## Proposal for the 03 series of amendments to UN Regulation No. 127 (Pedestrian safety) – document GRSP/2019/18

The text reproduced below was prepared by the experts from OICA to amend the definitions and specifications as well as the Annex 1, Part 1. It is a revised counterproposal to document ECE/TRANS/WP.29/GRSP/2019/18 submitted by Germany and the OICA informal document GRSP-67-07. The modifications to the current text of the UN Regulations are marked in bold for new or strikethrough for deleted characters.

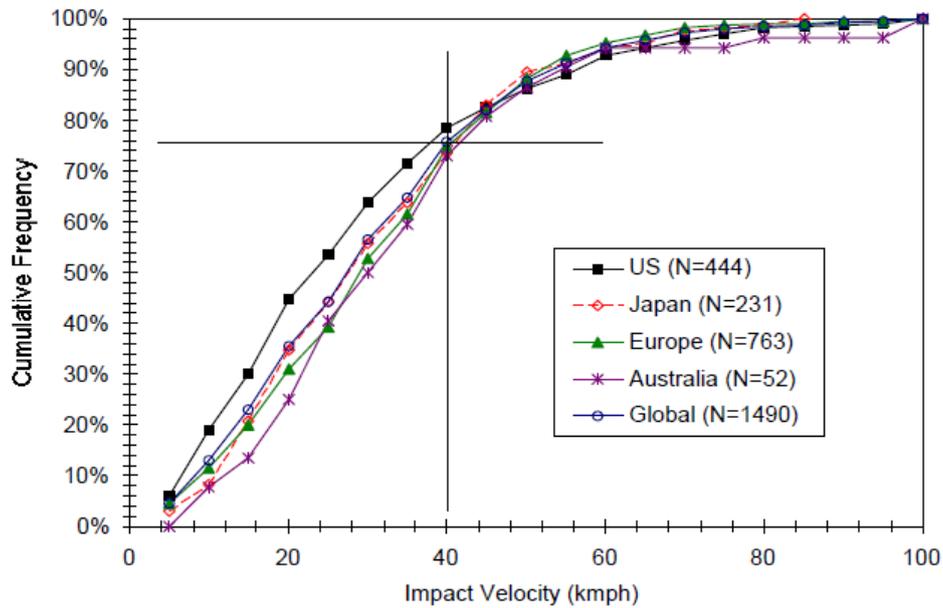
1. UN Regulation No. 127 addresses impacts with a pedestrian up to 40 km/h. Therefore, an impact velocity of 11.1 m/s (40 km/h) has been chosen to address a large amount of Maximum Abbreviated Injury Scale 1+ pedestrian accidents (see diagram below).
2. The availability of active suspensions allows the development of a system which could change the vehicle height while driving (up to a defined driving speed, e.g. up to 39 km/h). Such a system would allow raising of the suspension for driving off road (SUVs mostly) or driving in a car park (sports cars). In this context, there have been discussions with some manufacturers about the relevance to pedestrian protection. Since the vehicle height has an influence on the headform test area (WAD) and on the test results for legform tests, all

possible vehicle heights up to a driving speed of 11.1 m/s (40 km/h) should be considered to be relevant for impact with a pedestrian. The proposal clarifies this issue.
